Access Compliance Report

Public Rights-of-Way

(Curb Ramps)

Intersection ID: 50544	Main Street: ALCEA_ST	Cross Street: CAYENNE_DR	Location: W
ADA ID: EBDAC01E9091	Ramp Type: PerpDiag	Initial Pass/Fail: Fail	Overall Compliance: No
Severity Score: 8.75			
Codes/Mitigation Info/Possible Solution		Field Measurements/Component Compliance

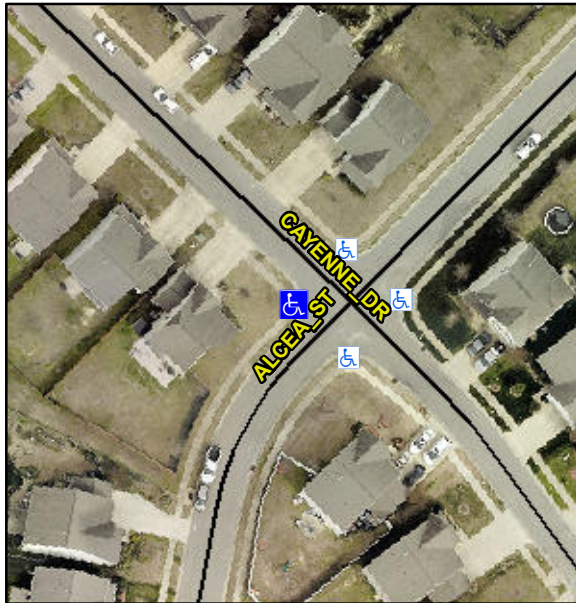
Not Found, R304.5.1

Compliance	Description	Data	Compliance	Description	Data
N/A	Ramp Length (in)	45.0	Yes	Ramp Slope (%)	7.3
No	Ramp Width (in)	45.0	Yes	Ramp XSlope (%)	0.5
N/A	Flare Type LT	N/A	N/A	Flare Type RT	N/A
N/A	Flare Slope LT (%)	N/A	N/A	Flare Slope RT (%)	N/A
N/A	Flare Traversable LT?	N/A	N/A	Flare Traversable RT?	N/A
N/A	Landing Length (in)	N/A	N/A	DWS Provided?	N/A
N/A	Landing Width (in)	N/A	N/A	DWS Contrast?	N/A
N/A	Landing Slope (%)	N/A	N/A	DWS Length (in)	N/A
N/A	Landing X Slope (%)	N/A	N/A	DWS Full Width?	N/A
N/A	Landing Curb? (Y/N)	N/A	N/A	DWS Offset (in)	N/A
N/A	Shared Landing?	N/A			
N/A	Gutter Ponding?	N/A	N/A	Gutter Slope (%)	N/A
N/A	Gutter Lip Ht (in)	N/A	N/A	Gutter X Slope (%)	N/A
N/A	Painted X Walk1?	No	N/A	Painted X Walk2?	No
	X Walk 1 Direction	To SE		X Walk 2 Direction	To NE
N/A	X Walk 1 Width (in)	N/A	N/A	X Walk 2 Width (in)	N/A
	X Walk 1 Slope (%)	0.6		X Walk 2 Slope (%)	0.8
	X Walk 1 X Slope (%)	0.3		X Walk 2 X Slope (%)	2.4

Remove & Replace Curb Ramp With Two New Directional Ramps or Equivalent.
